10/13/95	ADDENDUM 1
DATE	REVISION
STATE OF HAWAII DEPARTMENT OF TRANSPORTATION HIGHWAYS DIVISION ROOF WALKWAYS COMMON WORK H-3 FINISH (UNIT III) FAIP NO. I-H3-1(75), UNIT III T.K. TUNNEL/ACCESS ROADS SCALE: 1" = 20' DATE: JUN 1995	
SHEET NO. 7A1	OF 5 SHEETS

STATE OF HAWAII
DEPARTMENT OF TRANSPORTATION
HIGHWAYS DIVISION
**ACCESS OPENING SAFETY
RAILING — HALAWA**
COMMON WORK
H-3 FINISH (UNIT III)
FAIP NO. I-H3-I(75), UNIT III
T.K. TUNNEL/ACCESS ROADS
SCALE: NONE
DATE: JUN 1995
SHEET NO. 7SI OF 6 SHEETS

POTABLE WATER TANK

FOR DETAIL AS-BUILT INFORMATION
REFER TO CONSTRUCTION SUBMITTALS

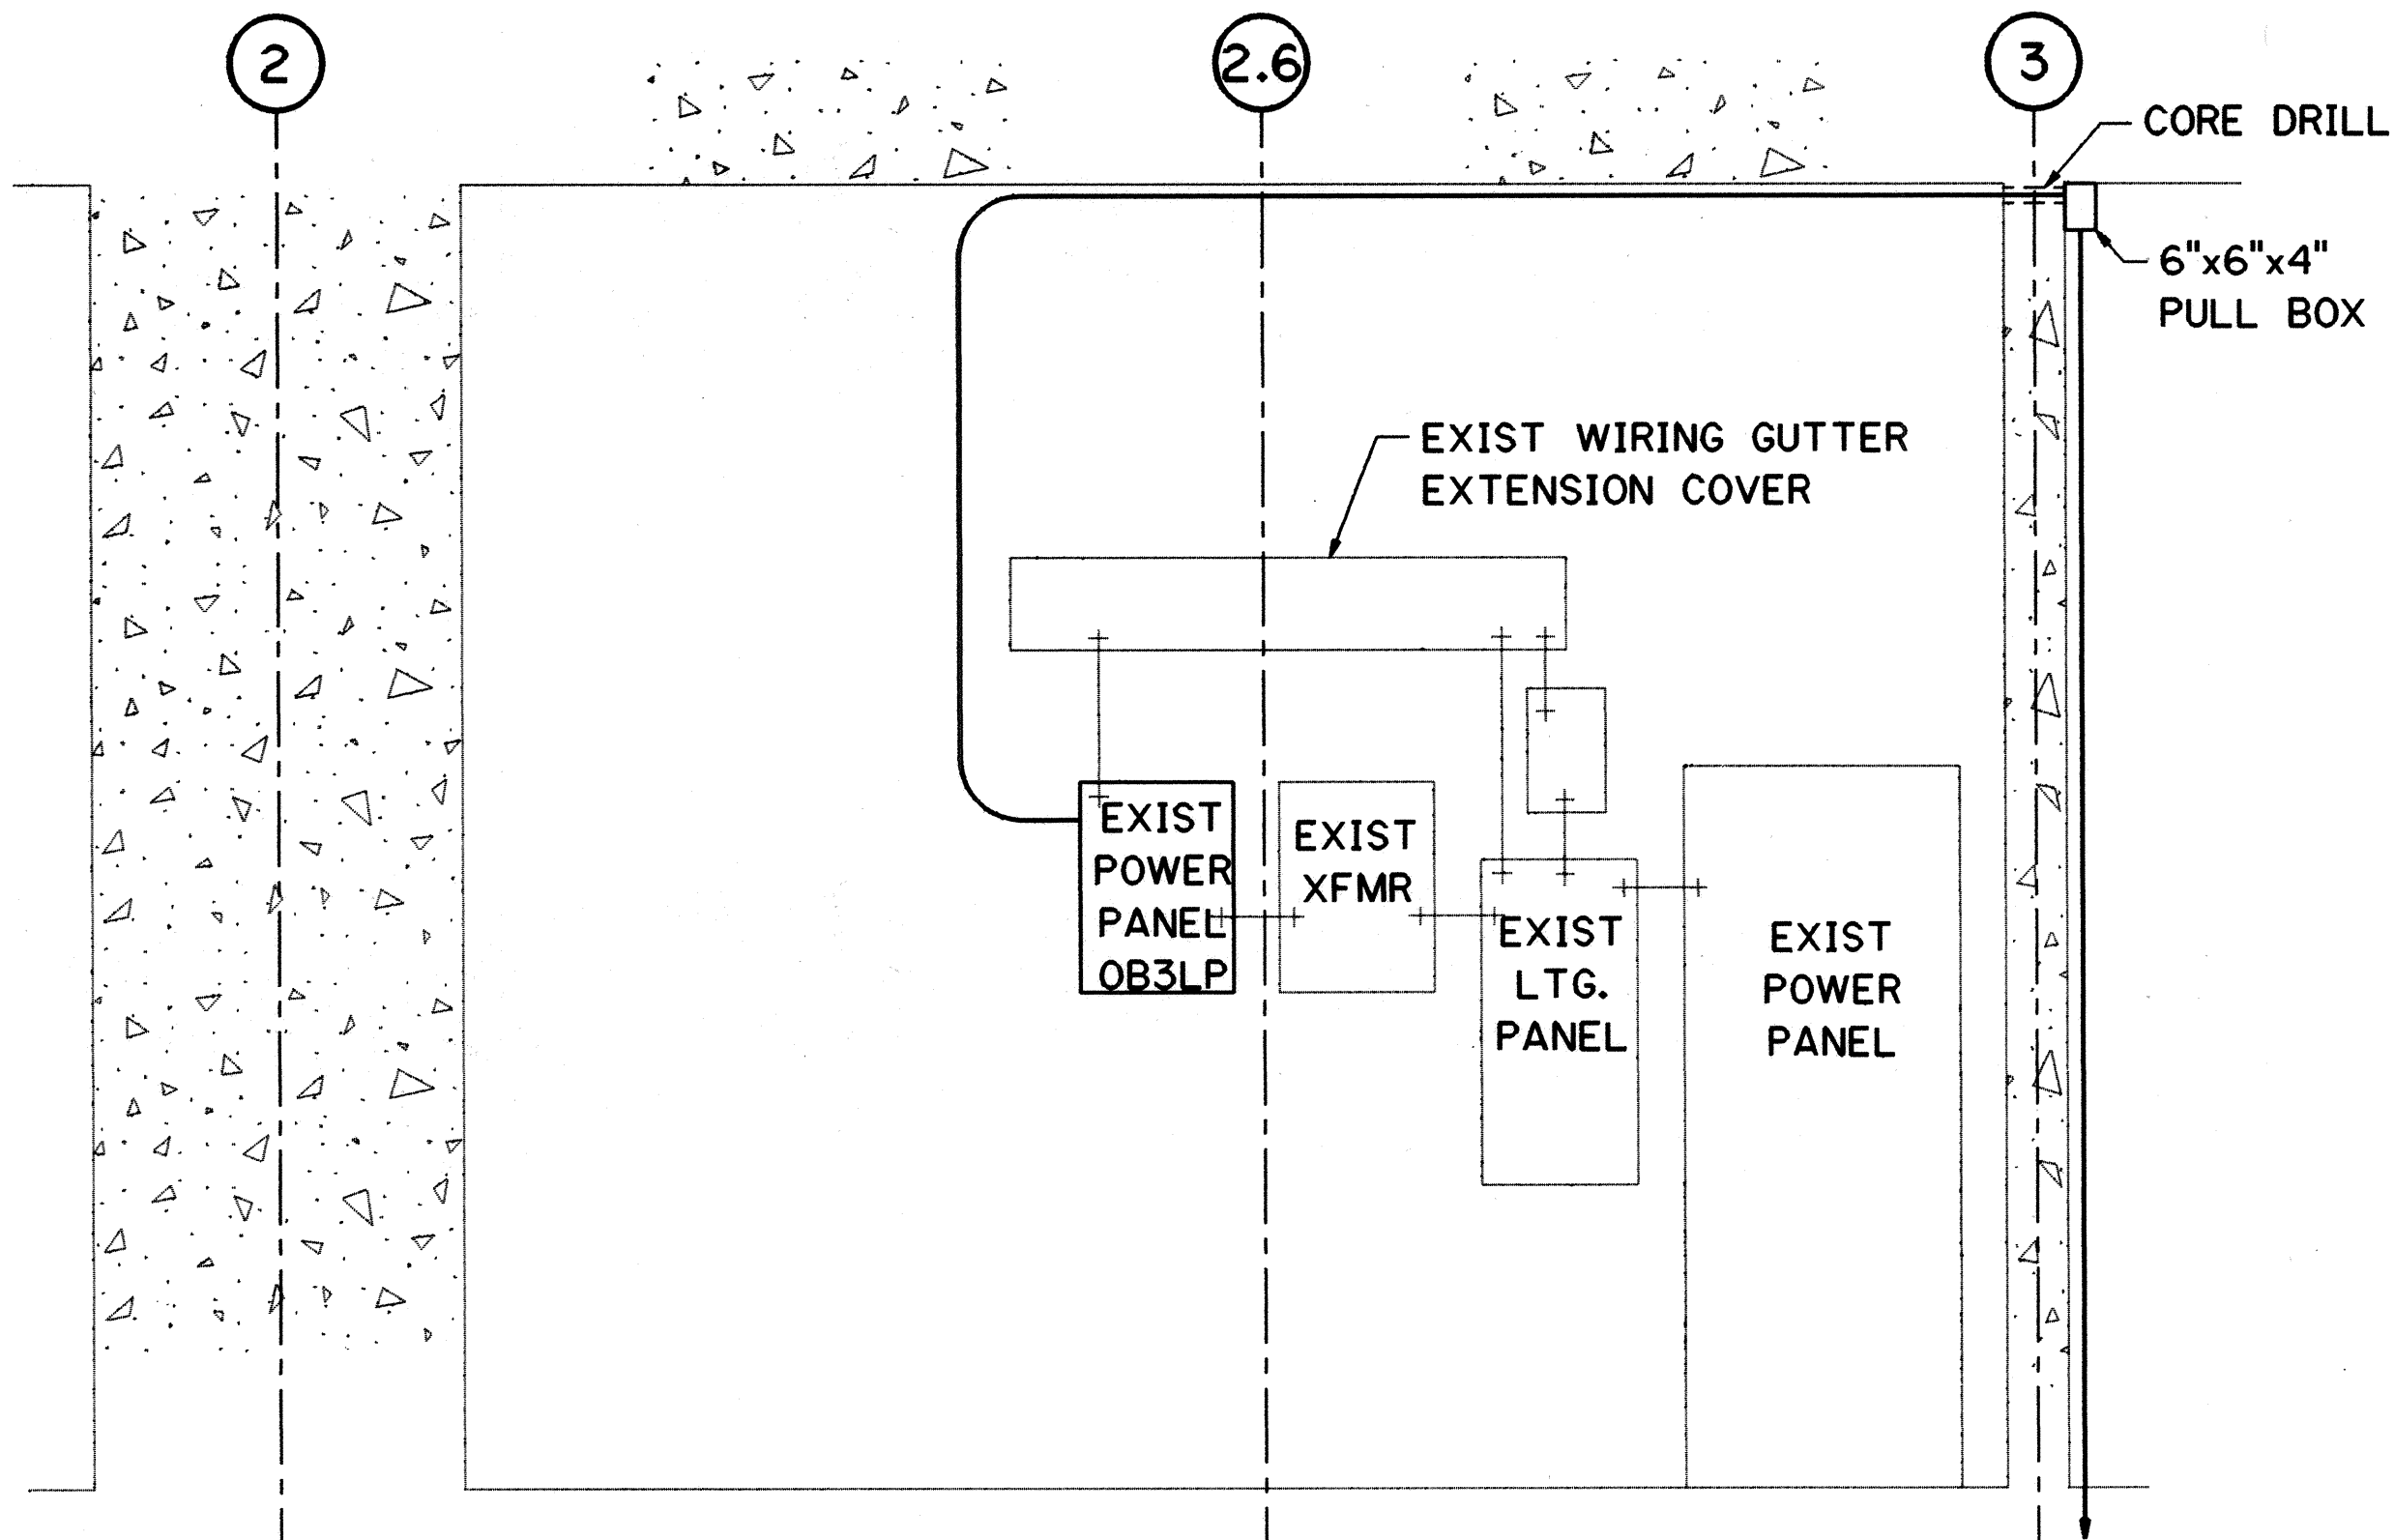
10/27/95	ADDENDUM 2-ADDED MONITORING CONDUIT
DATE	REVISION
STATE OF HAWAII DEPARTMENT OF TRANSPORTATION HIGHWAYS DIVISION	
HAIKU WATER TREATMENT	
POWER PLAN	
COMMON WORK	
H-3 FINISH (UNIT III)	
FAIP NO. I-H3-1(75), UNIT III	
T.K. TUNNEL/ACCESS ROADS	
SCALE: AS SHOWN	DATE: JUN 1995
SHEET NO. 7E2	OF 6 SHEETS

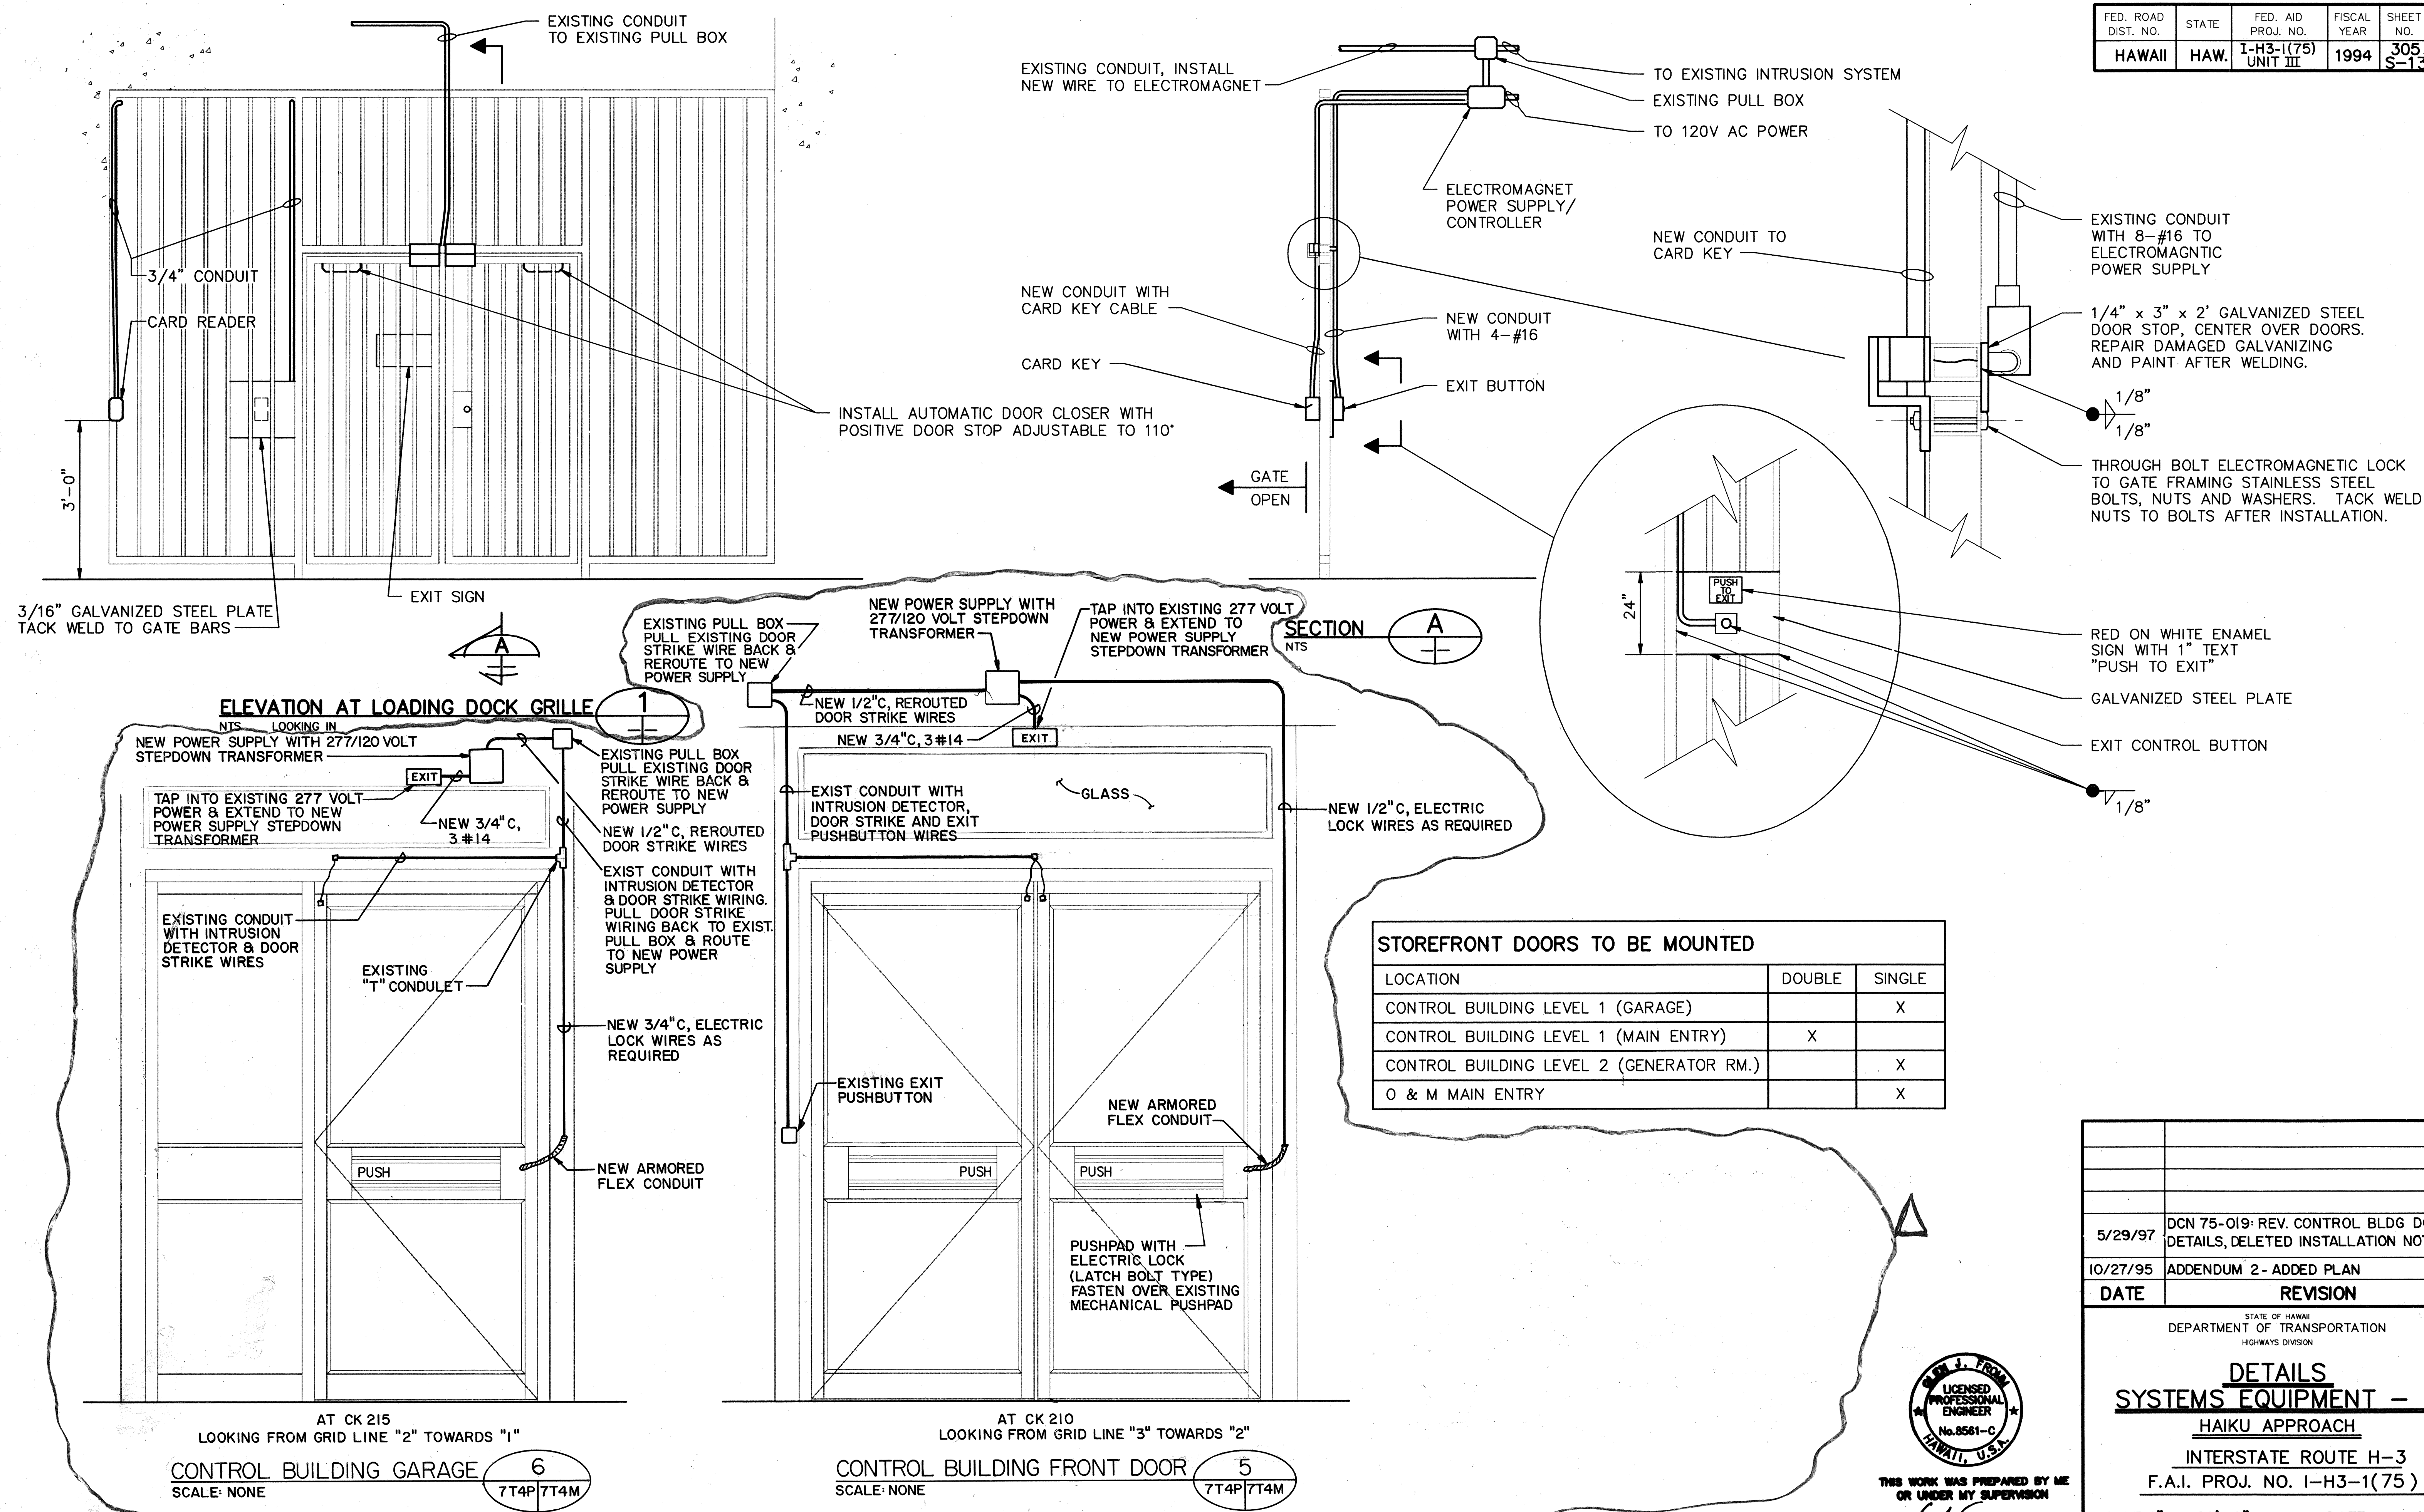
5/29/97	DCN 75-019: REV. CONTROL BLDG DOOR DETAILS, DELETED INSTALLATION NOTES
10/27/95	ADDENDUM 2- ADDED PLAN
DATE	REVISION
